VENTURA ROAD ELECTRONIC BILLBOARD

Response to Comments on Public Review Draft
Initial Study/Mitigated Negative Declaration
State Clearinghouse Number 2022060700

Prepared for
City of Oxnard
Community Development Department

October 2022

Figure 1. Unincorporated Residential Zones (circled in green) that need to be evaluated for direct, indirect and cumulative impacts due to the proposed ordinance and billboard projects.

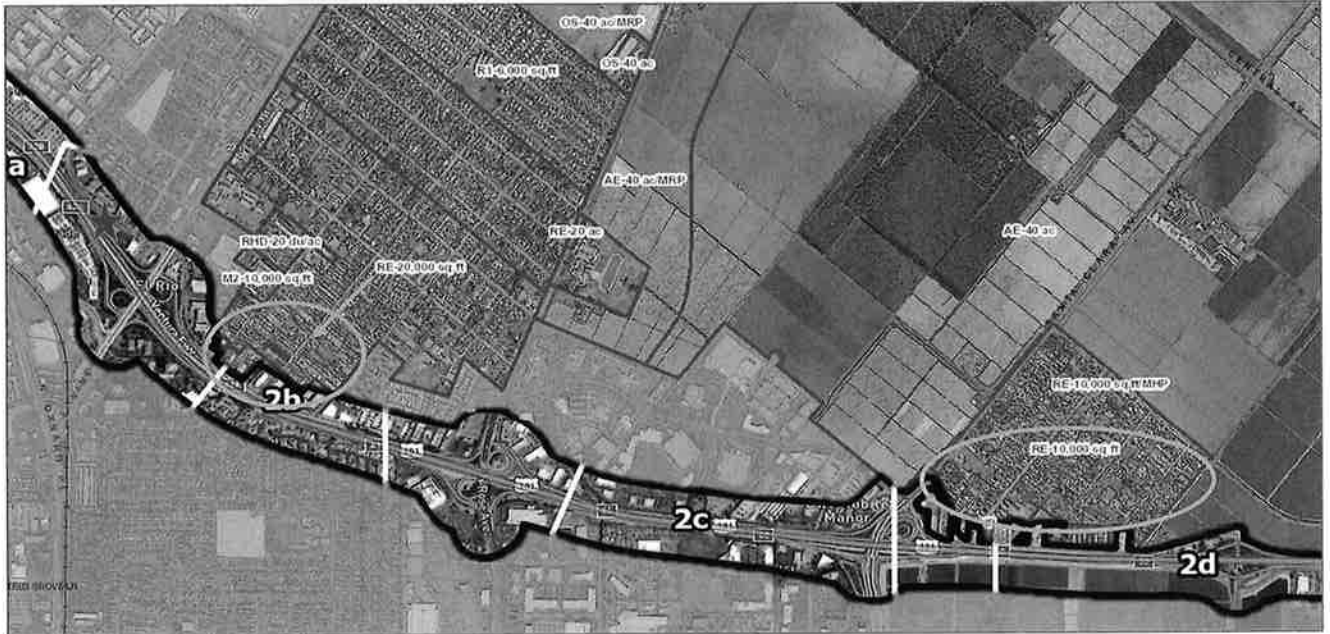
Setbacks: The ordinance should be revised to consider residential zoned unincorporated properties located adjacent to the proposed ordinance planning area where electronic billboards could be sited (see circled areas in Figure 1 below). As drafted, the ordinance could allow billboards to be sited within a few feet of residential zones in the unincorporated area.
